**Subject:** October 17th, 2023, Hybrid Development Services Committee Plan 23 131107

**Reference:** Application number PLAN 23 131107  
City Park (Town Crier) Homes Inc (applicant)  
7 Town Crier Lane, Markham

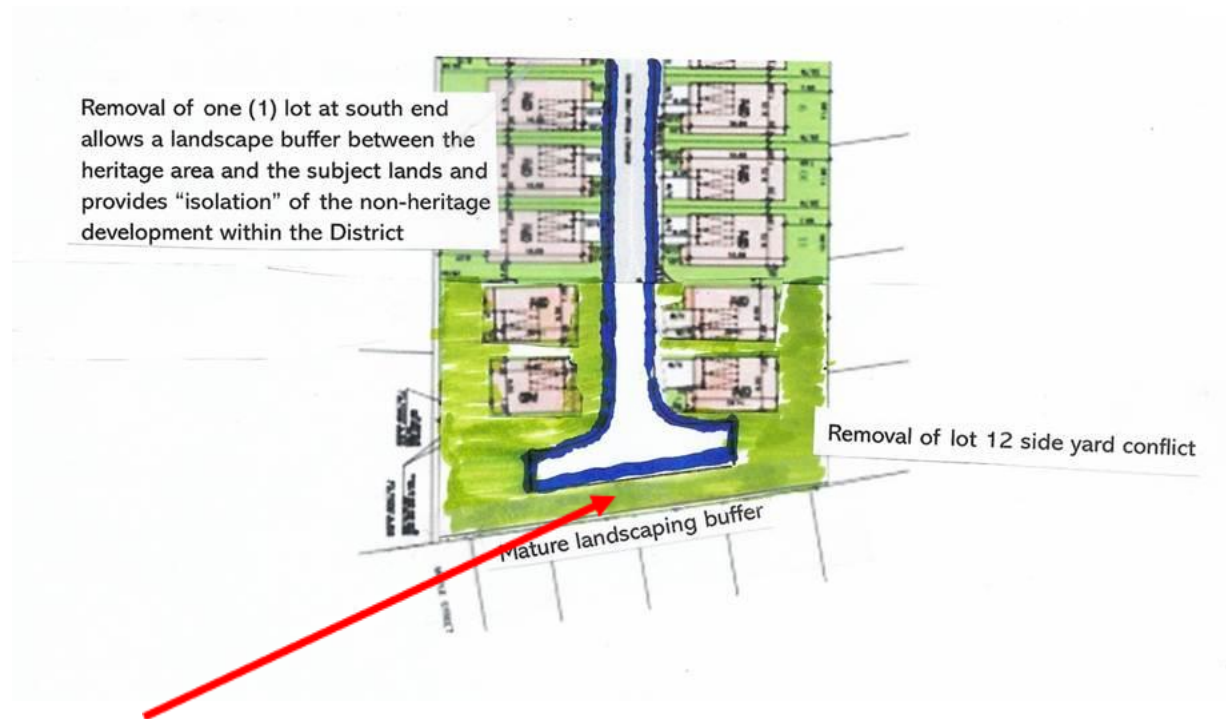
Removal of one (1) lot at south end allows a landscape buffer between the heritage area and the subject lands and provides "isolation" of the non-heritage development within the District

5m landscape buffer separates the non-heritage development from the Markham Village Heritage Conservation District removing precedent argument.

If staff’s position is to be supported by Council, and isolationism is to be relied upon as a basis for approval, then we would ask for a redesign of the south end of the subject property to create a distinct buffer zone between the existing Heritage District and the Proposed Development. This

sketch shows a 5m mature landscaping strip between the subject lands and those lands that staff believe to be the Heritage District to the south. A 5m mature landscaping strip would create the isolation and distinguishment from the Heritage District that staff support in their report to Council.

This 5m mature landscape buffer and the hammerhead road design proposed at the south end of the subject property does supports staff's opinion that, "There is a different character within this development from what exists on Parkway Avenue and on Markham and Elm Streets."<sup>[iv]</sup> The buffer enacts and strengthens the staff position. By defining the different development areas with a landscape buffer, staff will achieve alignment with Markham's strategic priorities. Specifically, isolation by landscaping and road design meets Markham's priority to show respect for the built environment.

Further, the hammerhead road design proposed at the south end of the subject property supports staff position of the elimination of the emergency fire access to Maple Street and solves the staff's concern of Lot 12's minimal side year setback. The herein proposed road design also provides additional areas for snow storage with the reduction of one (1) lot.

THE MARKHAM VILLAGE  
HERITAGE CONSERVATION DISTRICT

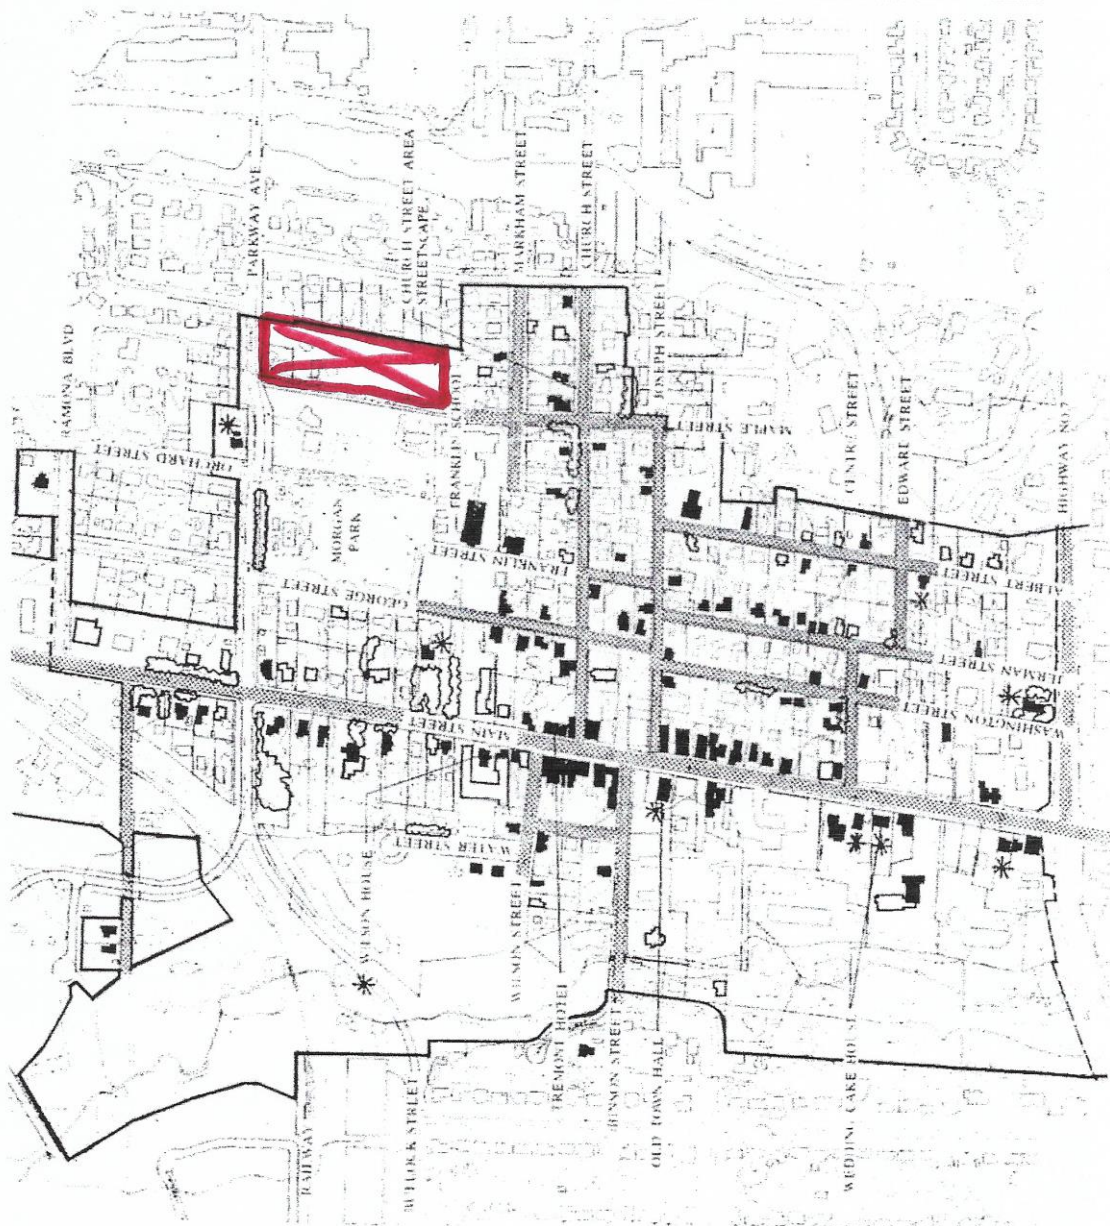
The Conclusion in the Council Report<sup>[i]</sup> contains an ambiguous statement that appears to present an error in fact to Council:

“Given the subject properties location in behind the rear yards of homes that are within the boundaries of the Markham Village Heritage Conservation District fronting Markham Street, there are no anticipated negative impacts to the existing historic character of the District.” (underlining added)

This does not clearly state the fact that the subject property itself is within the Markham Village Heritage Conservation District (hereinafter “Heritage District”). As evidence, please see the plan at the bottom of this email with the subject property shown in red.<sup>[ii]</sup>
